OGDEN VALLEY PLANNING COMMISSION

PLANNING MEETING AGENDA

Staff Report to the Ogden Valley Planning Commission

Staff Report for Ogden Valley Planning Commission

Exhibit A

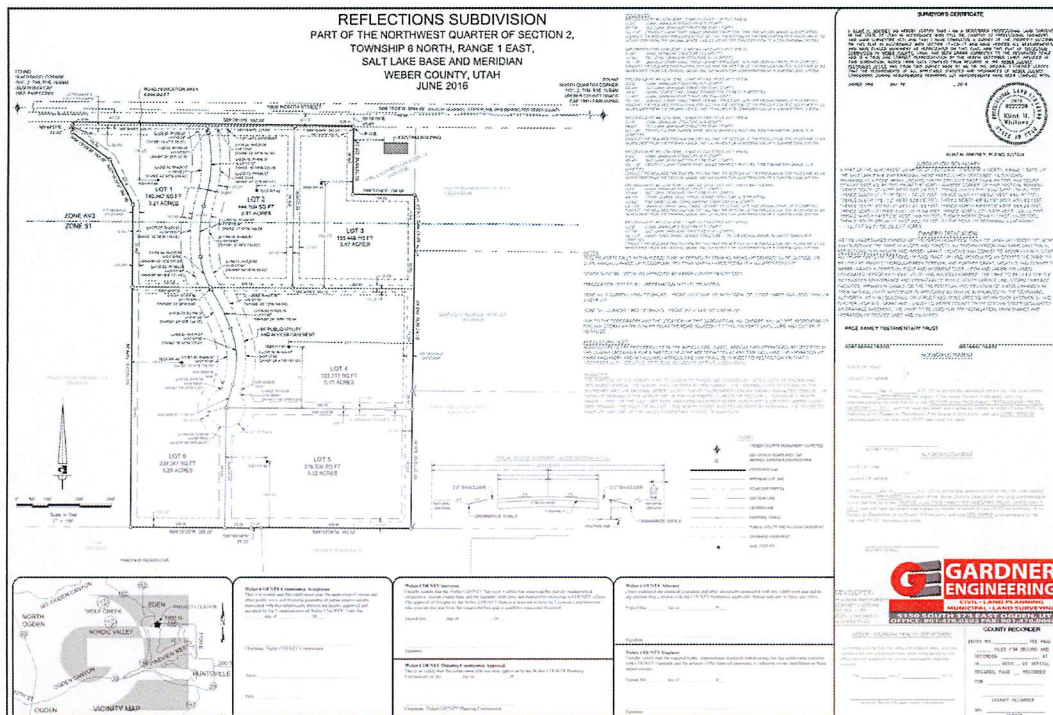
1. Per the County subdivision ordinance, a preliminary plan is required to be submitted with the subdivision application:
 1. The determination of the access amendment needs to be resolved first to see **if the concept of an access easement is approved.**

2. **The right of way dedication for 1900 N by the general plan would be for a 40 foot half street.**
2. The proposed subdivision will need to have curb, gutter and sidewalk **along 1900 North similar to that provided easterly along 1900 North in the vicinity of the school. Regarding the improvements along the proposed access easement as a bare minimum there will need to be a deferred by the planning commission to be signed by the developer prior to final approval.**

3. A note will need to be added to the plat stating: "Due to the topography and the location of this subdivision all owners will accept responsibility for any storm water runoff from the road adjacent to this property until curb and gutter is installed."

4. Because soil conditions vary throughout the county, it is now necessary to provide an engineered pavement design showing required sub-base, road-base, fabric, and asphalt thickness as needed for soil type. Asphalt thickness shall not be less than 3 inches. The county engineer is now requiring a minimum of 8" of 4" minus sub-base and 6" road-base. Compaction tests on both will be required

Exhibit A

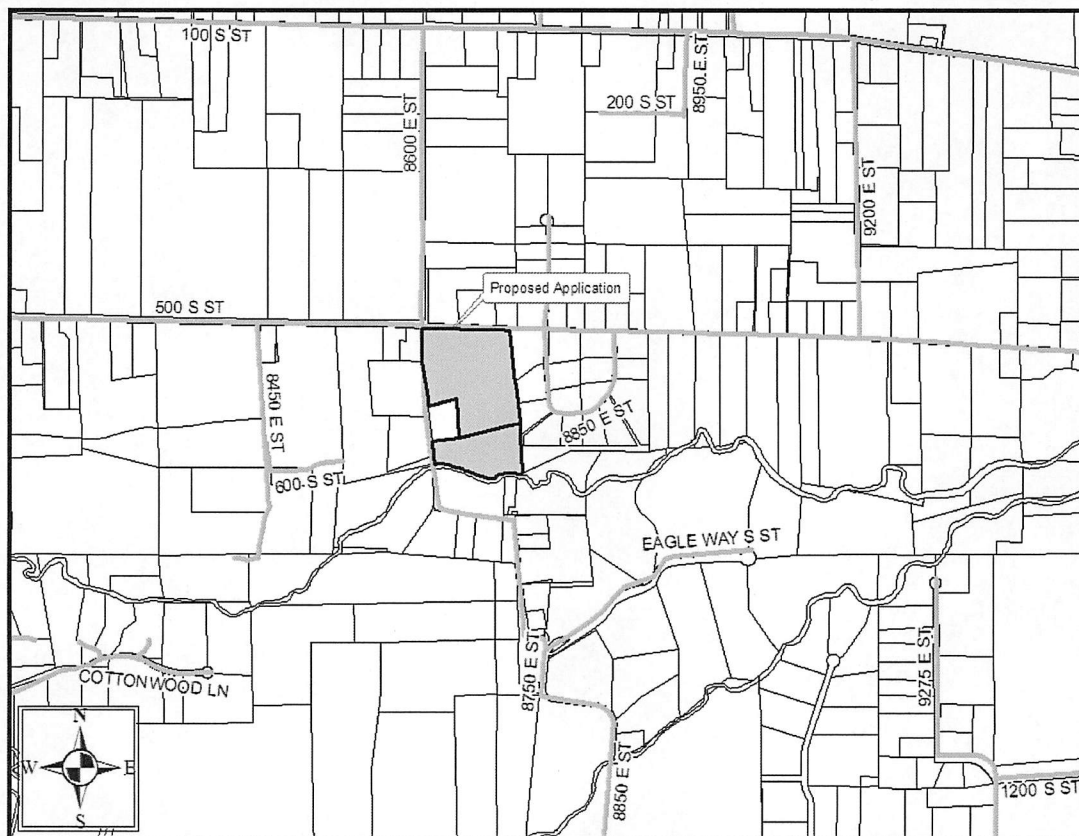
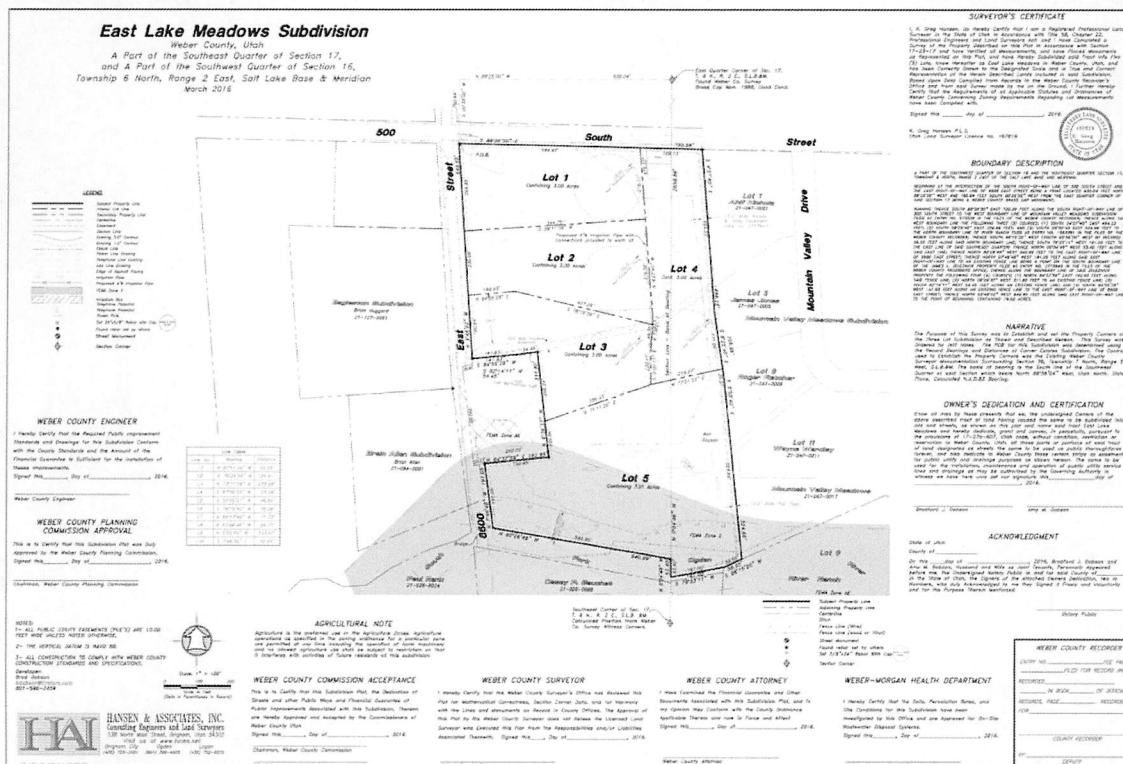
1. Per the County subdivision ordinance, a preliminary plan is required to be submitted with the subdivision application.
 1. The preliminary plan shall be prepared in conformance with the requirements of this ordinance and all other County codes and regulations regulating the subdivision of land. The preliminary plan shall be drawn to a scale not smaller than one hundred (100) feet to the inch and shall show:

3. Plans or written statements prepared by a licensed civil engineer regarding the width and type of proposed pavement, location, size, and type of proposed sanitary sewers or other sewage disposal facilities, proposed water mains and hydrants and other proposed storm water drainage facilities and other proposed improvements such as sidewalks, planting and parks and any grading of individual lots. Engineering drawings may be required during preliminary approval in subdivisions.

4. A note will need to be added to the plat stating: "Due to the topography and the location of this subdivision all owners will accept responsibility for any storm water runoff from the roads adjacent to these properties until curbs and gutters are installed."

7. Because soil conditions vary throughout the county, it is now necessary to provide an engineered pavement design showing required sub-base, road-base, fabric, and asphalt thickness as needed for soil type. Asphalt thickness shall not be less than 3 inches. The county engineer is now requiring a minimum of 8" of 4" minus sub-base and 6" road-base. Compaction tests on both will be required.
